CAN YOU NOTE THE PROBLEM AND THE SOLUTION?

AG | A L L U R I N G G L A S S

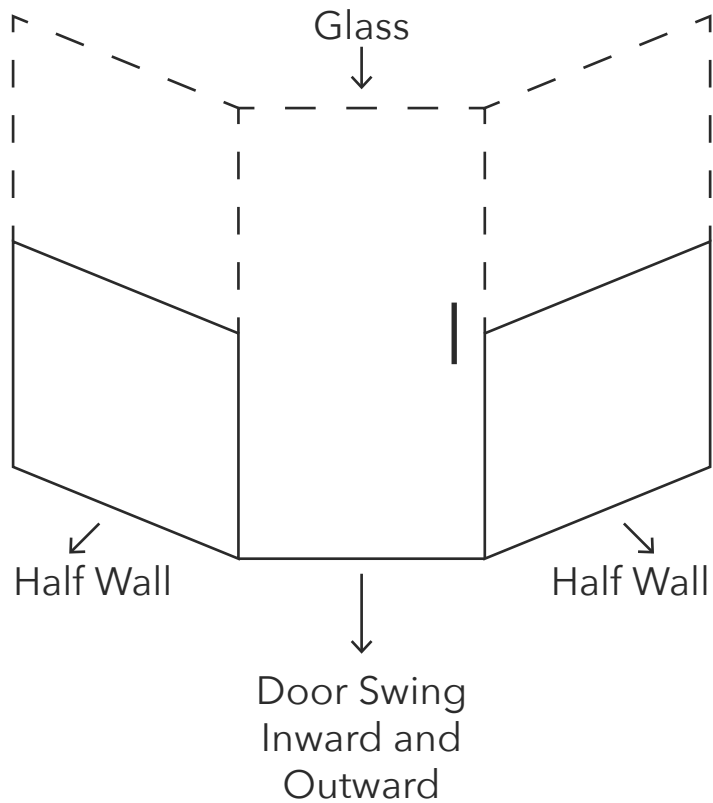
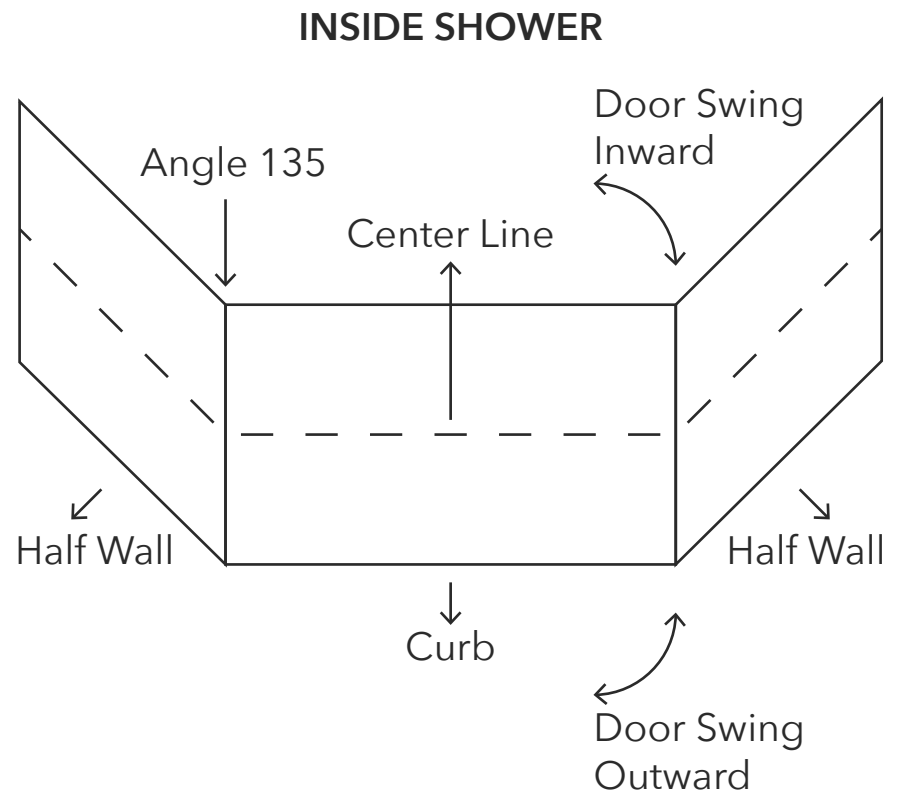
In the photo on the left, installing a door would force it to open outward only. Additionally, the hinge would be extremely difficult to install correctly, making it nearly impossible to achieve proper self-centering.

In contrast, the photo on the right allows the door to swing freely in both directions, both inward and outward, while also providing a clean, reliable hinge installation that supports proper self-centering.

Door width not to exceed 36"
